BURLINGTON DEVELOPMENT REVIEW BOARD

Tuesday November 19th, 2019, 5:00 PM

To: Development Review Board
From: Mary O'Neil, AICP, Principal Planner
Date: November 19, 2019
RE: ZP20-0408CU; 747 Pine Street

To: Development Review Board
From: Mary O'Neil, AICP, Principal Planner
Date: November 19, 2019
RE: ZP19-0980CA/MA, 110 Riverside Avenue

DETAIL "B"		
------------	--	--

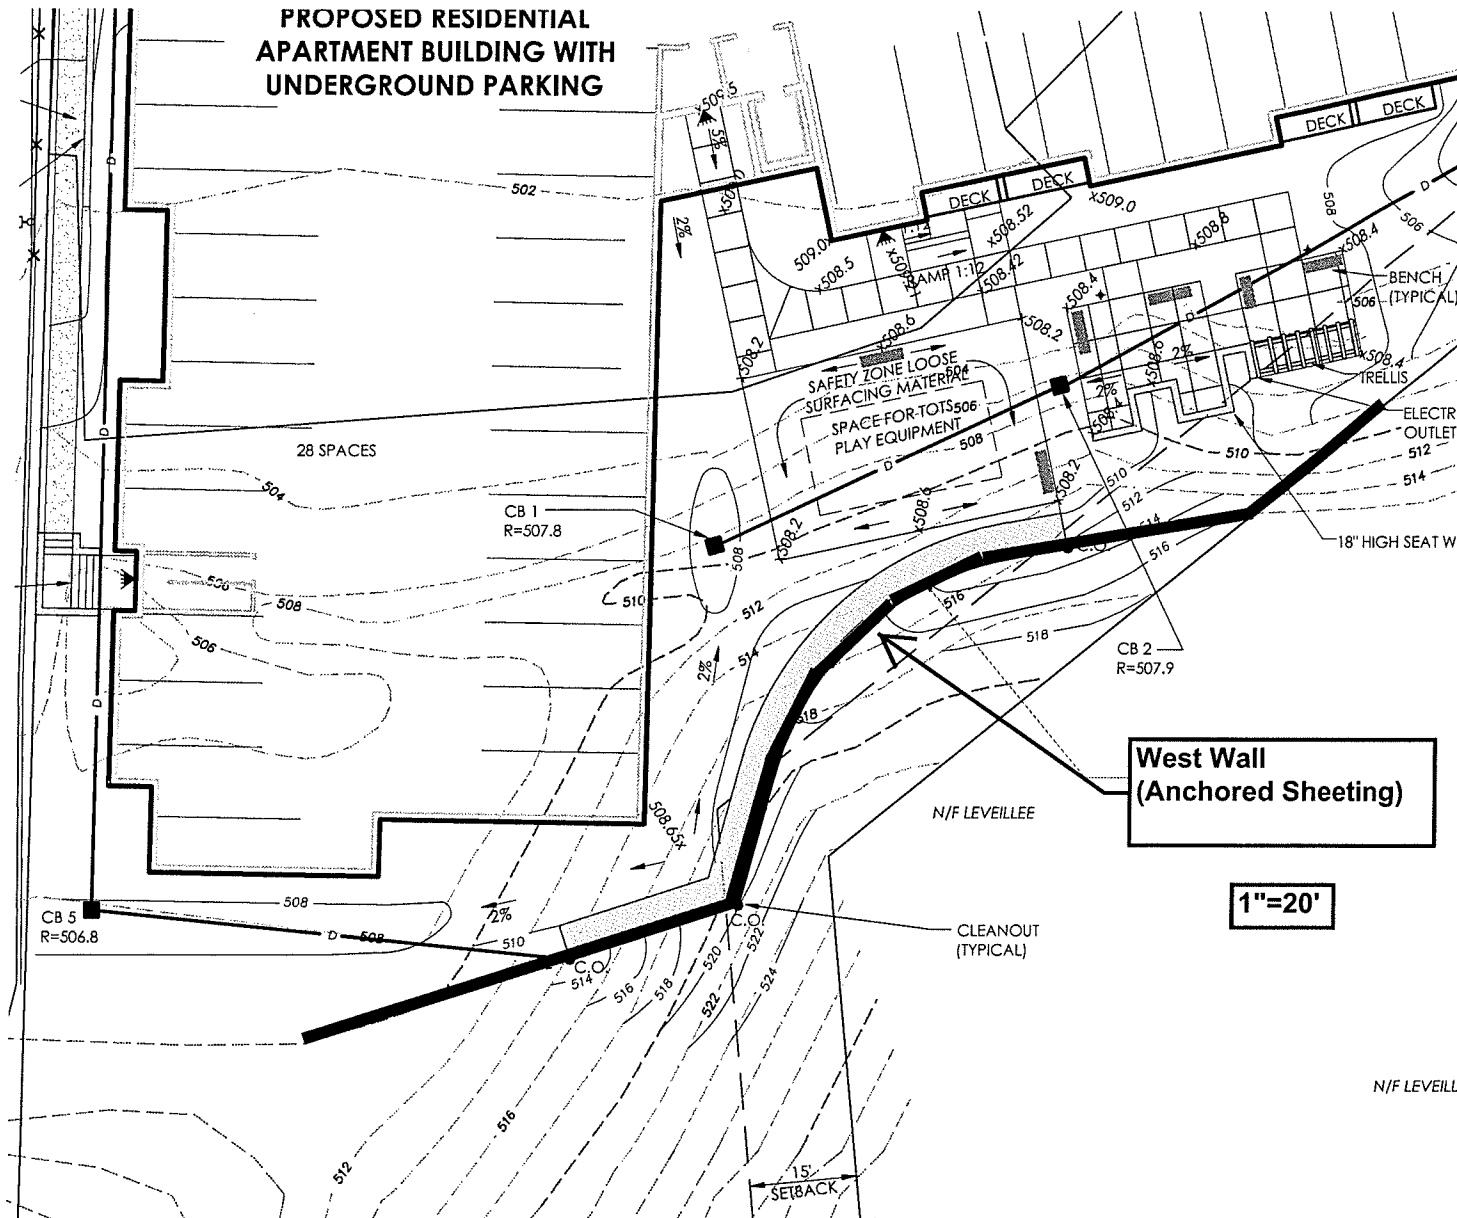
- There isn't a level of detail that indicated precisely where these retaining wall systems are proposed. I cannot decipher precisely where these two wall sections are on 110 Riverside Avenue given there refer only to an east and west wall.

- The Drawing "Detail B" for the West Wall does not show dimensionally how long these proposed anchors are, how many are being proposed, and from the drawing it suggests that they will be encroaching on the adjacent property(address unknown), Property rights Acquired(Unknown)

- There needs to be a Licensed Surveyor preparing a set of Site Plans that spatially places these two proposed retaining wall system spatially in context,
